Service Bulletin

Bulletin No.: 06-02-35-002B

Subject: Stabilitrak/Active Handling Light On, Service Stabilitrak/Active Handling Message on DIC, DTC C0710 Steering Wheel Position Sensor (SWPS) Signal Set (Install Clip in SWPS Connector)

Models: 2008 Buick Lucerne
2004–2008 Cadillac XLR
2006–2008 Cadillac DTS
2005–2008 Chevrolet Corvette
with Steering Wheel – Tilt, Telescoping (RPO N37 or N38)

2030089

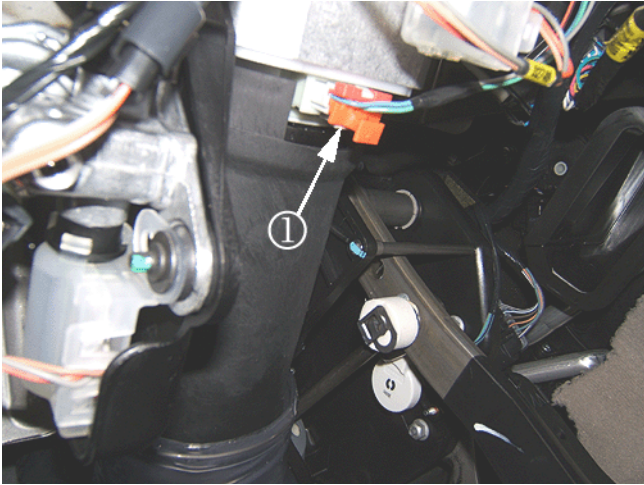
The most likely cause of a DTC C0710 on a vehicle equipped with telescoping/tilt steering wheel is high resistance in SWPS connector C202. Fretting terminal corrosion may be present in the SWPS connector due to the telescoping motion of the steering column. When the steering column is telescoped in and out, the female terminals within the SWPS connector may move on the male terminals of the SWPS. This movement between the terminals may cause a high resistance condition in the SWPS connector.

1. Remove the driver's side closeout (insulator) panel.
2. Locate the SWPS connector that connects to the steering angle sensor, located on the lower center of the steering column.

3. Install the clip (1), P/N 19179794, into the connector. This clip will act as a terminal positive assurance (TPA) and prevent any movement of the terminals.
4. Reinstall the closeout panel.
5. Clear the DTC with a scan tool and road test the vehicle.
6. If DTC C0710 resets during the road test, refer to DTC C0710 in SI.
